**National Committee on
Seismic Design Parameters (NCSDP)
for River Valley Projects**

**MINUTES
OF
32nd MEETING
(12th July, 2017)**

**MINUTES OF THE 32ND MEETING OF
NATIONAL COMMITTEE ON SEISMIC DESIGN PARAMETERS FOR RIVER VALLEY PROJECTS
HELD ON 12TH JULY, 2017 AT CWC, NEW DELHI**

**ESTIMATION OF SITE-SPECIFIC SEISMIC DESIGN PARAMETERS FOR
NAITWAR MORI HYDRO ELECTRIC PROJECT, UTTARAKHAND**

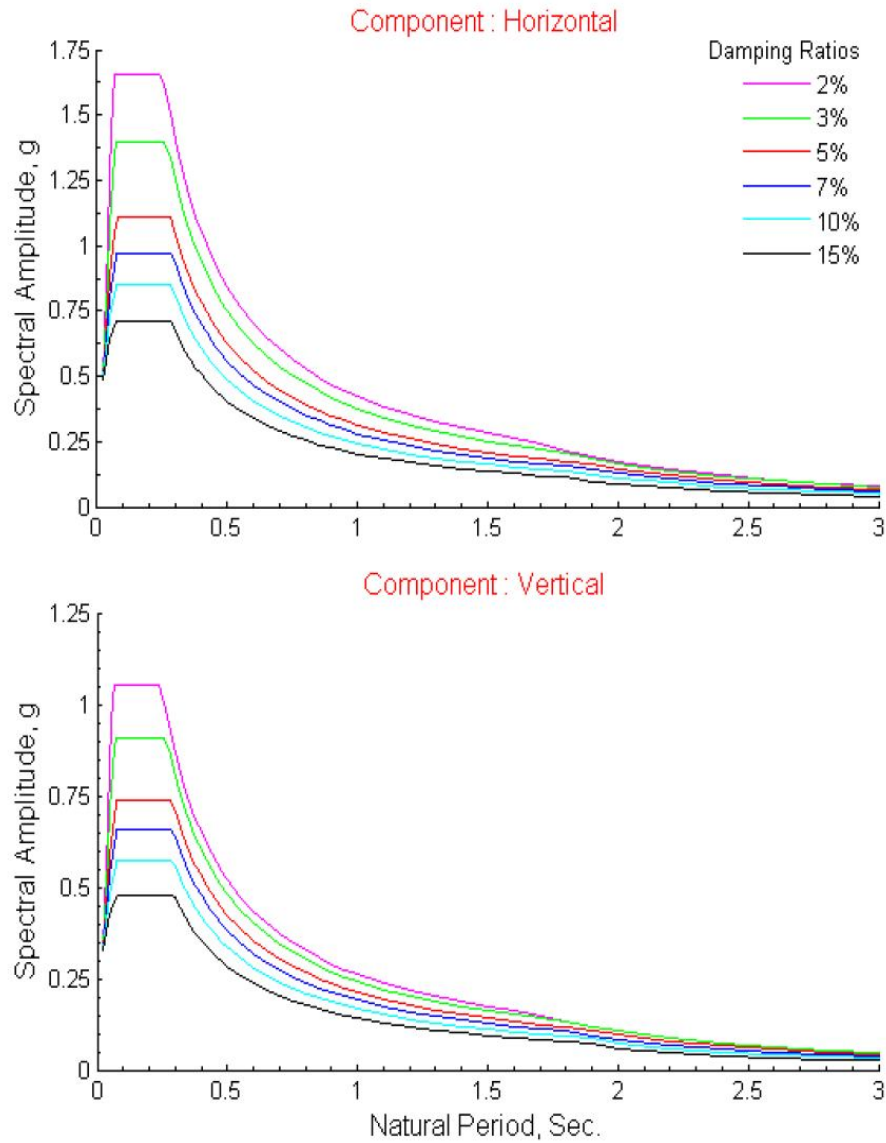
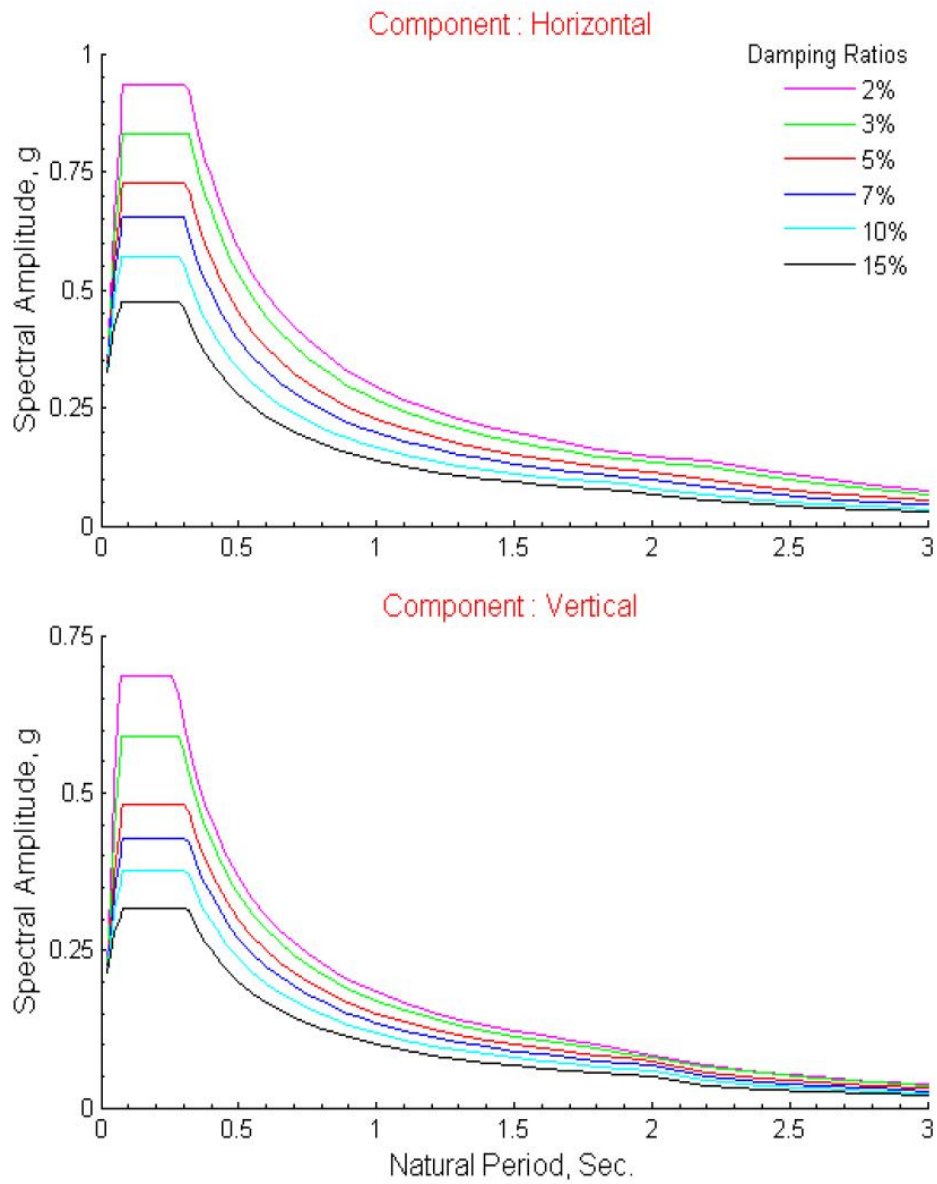
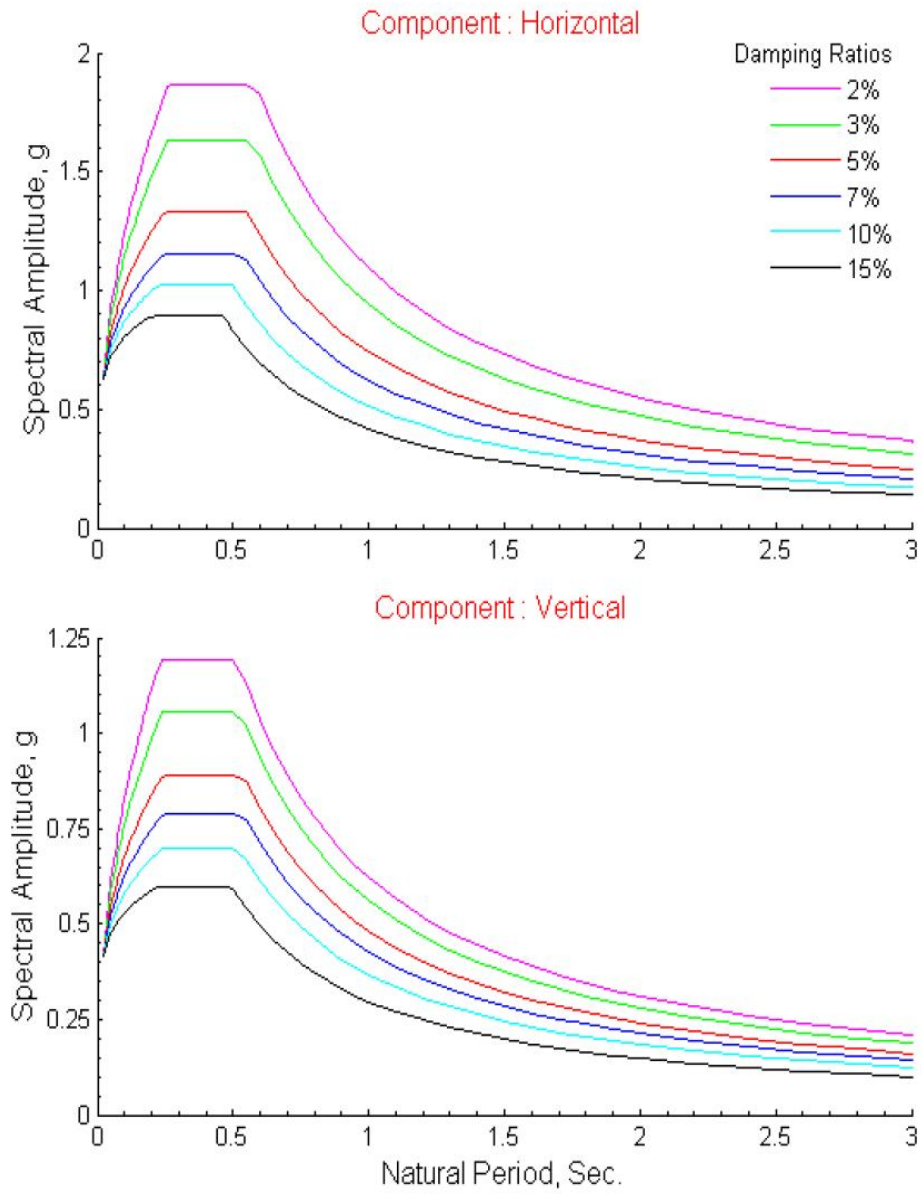
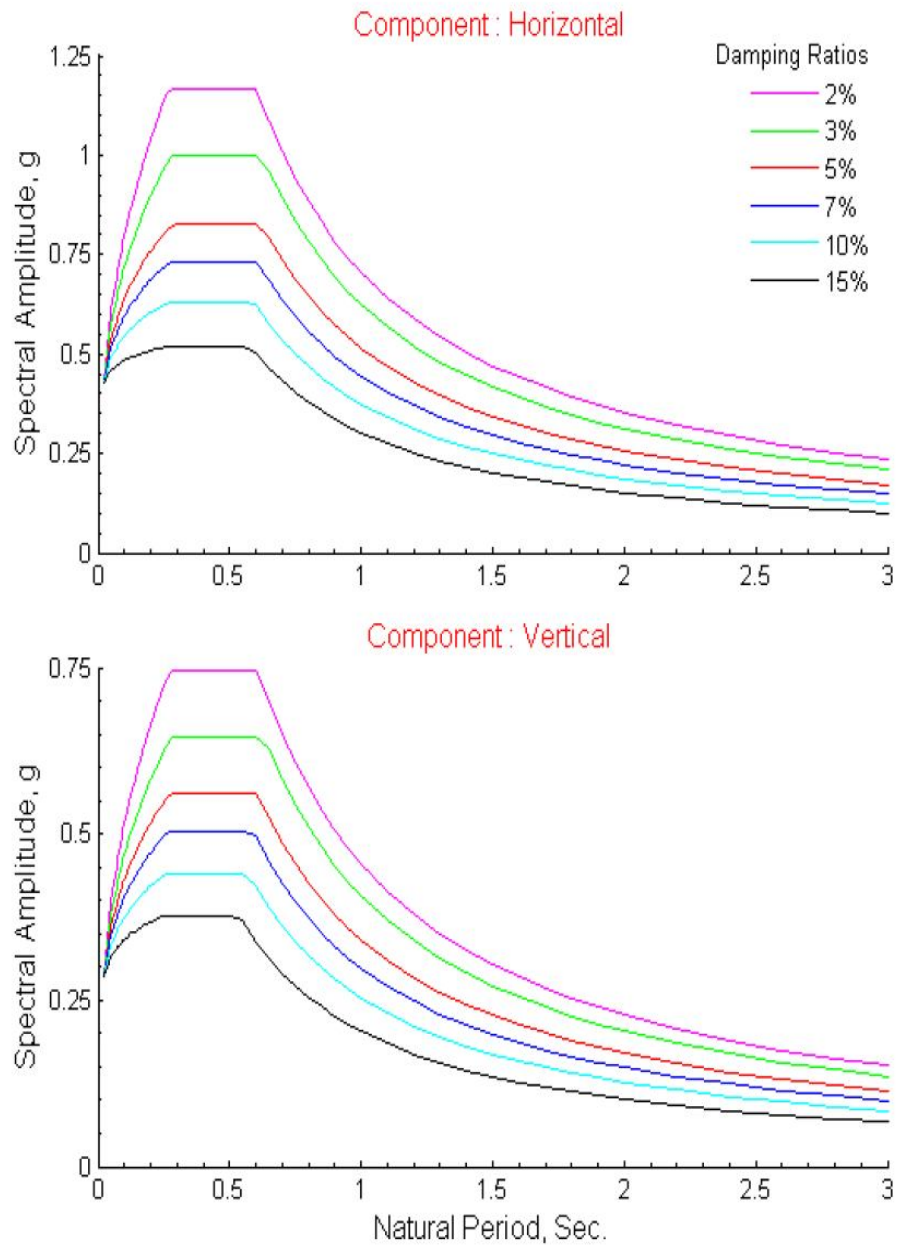
A presentation on the study report was made by the project authorities. During the discussion, it was mentioned that the design response spectra should be modified as discussed under item 32.3.1 above. Accordingly, CWPRS, Pune has supplied the modified design response spectra alongwith modified report vide their letter dated 17.08.2017 (*Annexure-II*).

As per the decision taken in the 32nd NCSDP meeting held on 12th July, 2017 to provide flat Design Response Spectra in the Site-specific Seismic Design Parameters study reports, the following technical reports are modified by including flat Design Response Spectra and the soft copies of the same are submitted herewith.

**ESTIMATION OF SITE-SPECIFIC SEISMIC DESIGN PARAMETERS FOR
RUPALIGAD RE-REGULATING DAM, INDIA / NEPAL**

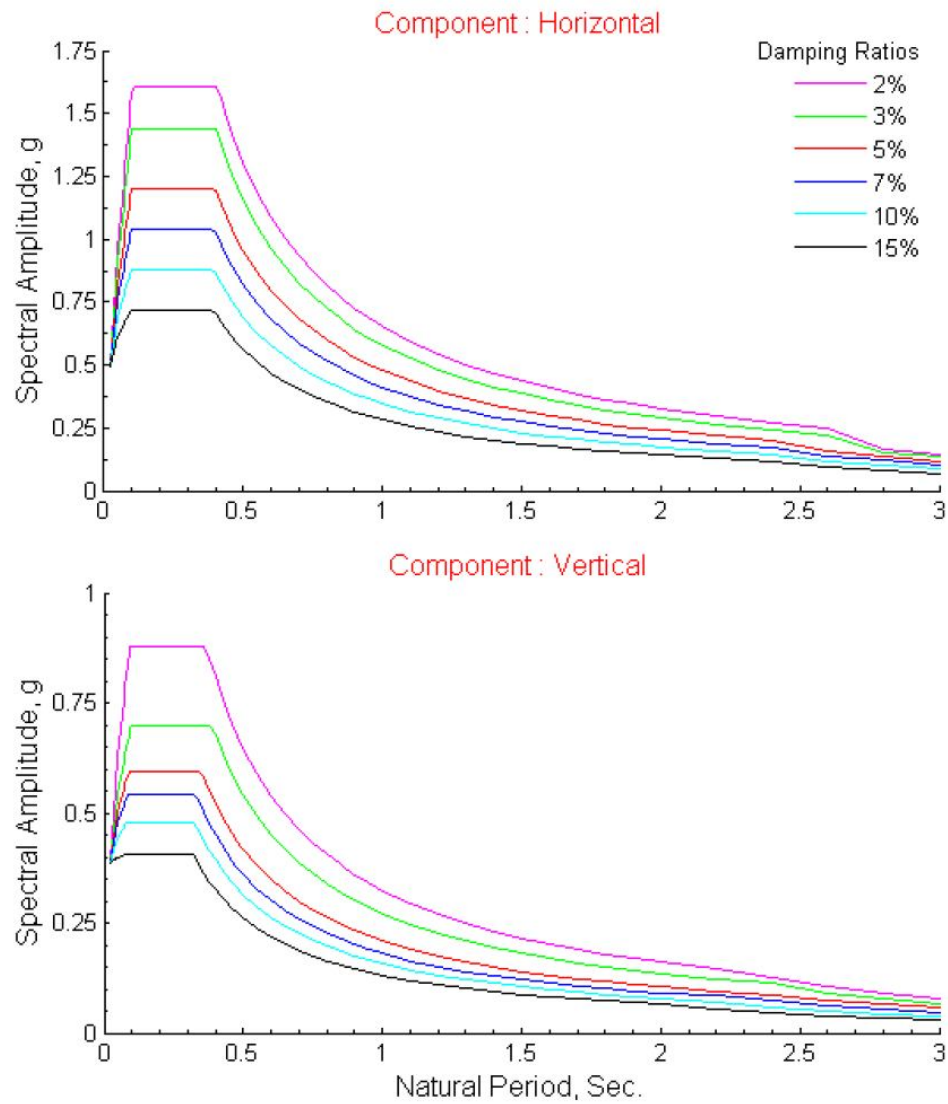
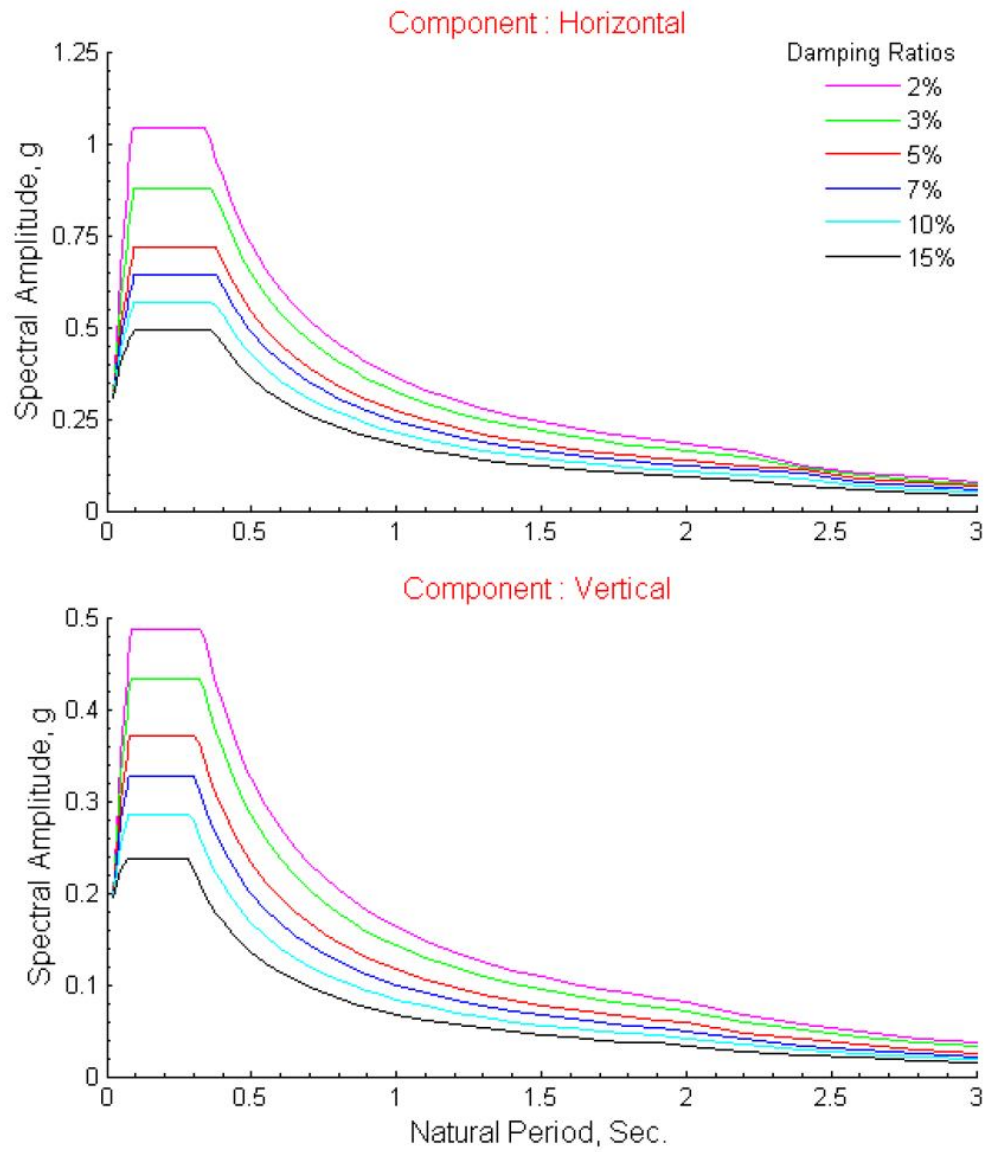
A presentation on the study report was made by the project authorities. During the discussion, Dr Yogendra Singh, IIT Roorkee stated that Target Response Spectra for both Pancheshwar and Rupaligad sites are different. In response, Dr G D Naidu, CWPRS Pune clarified that the seismo-tectonic sources governing the Deterministic Target Response Spectra for both Pancheshwar and Rupaligad sites are different. The major contribution to the deterministic spectral amplitudes for both sites is from decollement surface. Considering the dip of decollement surface and the site location of Rupaligad project

(lies south of Pancheshwar), the rupture distance considered for Rupaligad site is slightly lesser than Pancheshwar. Hence the deterministic target response spectra shows slightly higher spectral amplitudes for Rupaligad project. The probabilistic target response spectrum also shows marginally higher spectral amplitudes for the Rupaligad site. Hence the spectral amplitudes of 5% damped target response spectra for Rupaligad sites are at the higher side. The estimated seismic design parameters for both the projects are very much close to each other. Further, it was also mentioned that the design response spectra should be modified as discussed under item 32.3.1 above. Accordingly, CWPRS, Pune has supplied the modified design response spectra alongwith modified report vide their letter dated 17.08.2017 (**Annexure-II**).

Figure 12: DBE (upper panel) and MCE (lower panel) levels of horizontal design response spectra with damping ratios of 2, 3, 5, 7, 10 & 15 % of critical damping.

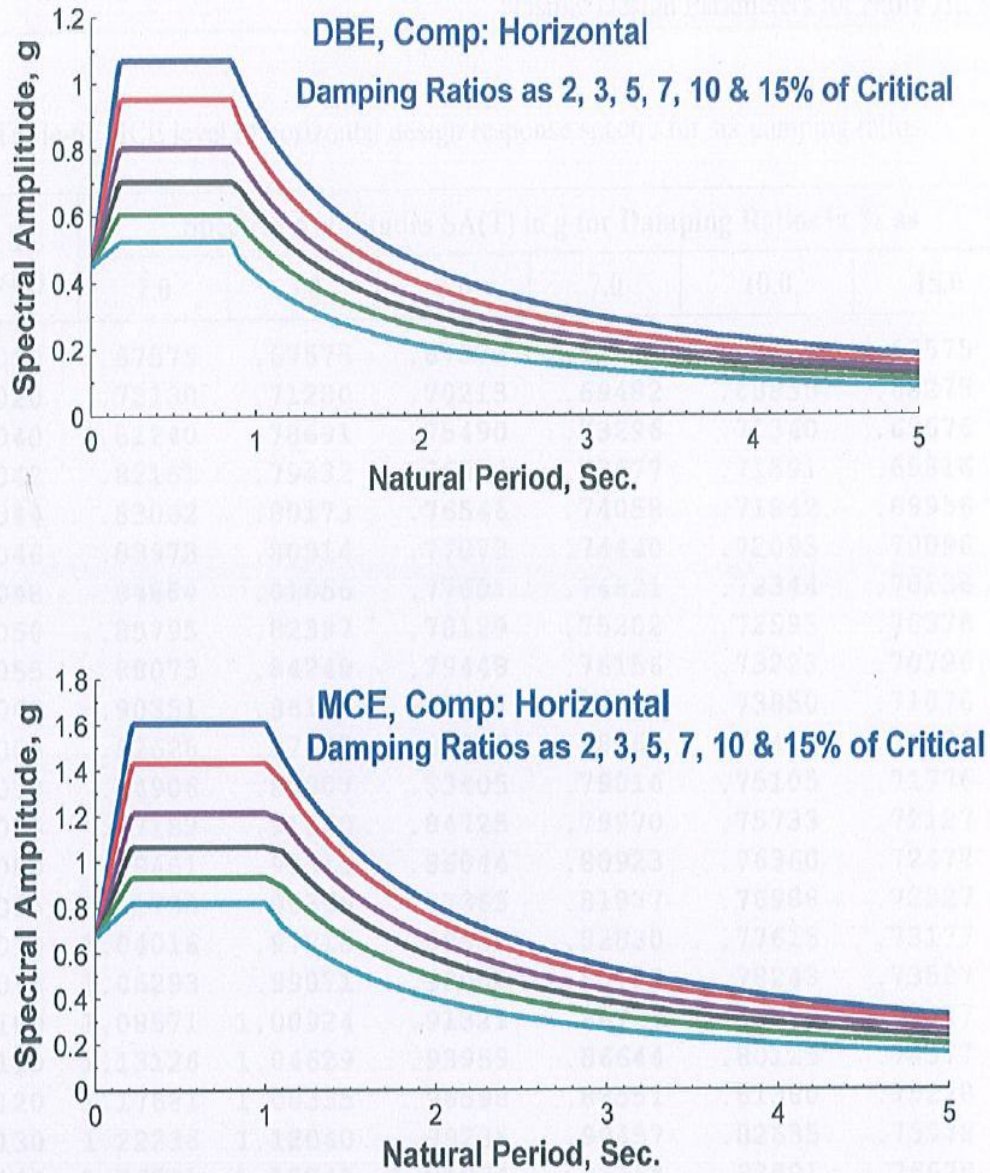
A presentation on the study report was made by the project authorities. The issue of carrying out the studies of the Project by the Individuals was discussed in detail before start of the meeting and decision taken is explained under item no.32.3 above. Further, the design response spectra also need to be modified as discussed under item no 32.3.1 above. Accordingly, the project authorities vide their letter no. SEL/NHEP/T/2017/372 dated 17.07.2017 (**Annexure-III**) have submitted the modified design response spectra and a copy of the updated report have also been supplied.

It is to submit that the Design Response Spectra (Fig.12 at Page 38 of the Site Specific Seismic Study Report) and the Table 6 and 7 (at Page 49-50 and 51-52 of the Report) have been revised in view of the discussions in the recent NCSDP Meeting on 12.7.2017 and submitted herewith for consideration and further needful action please.
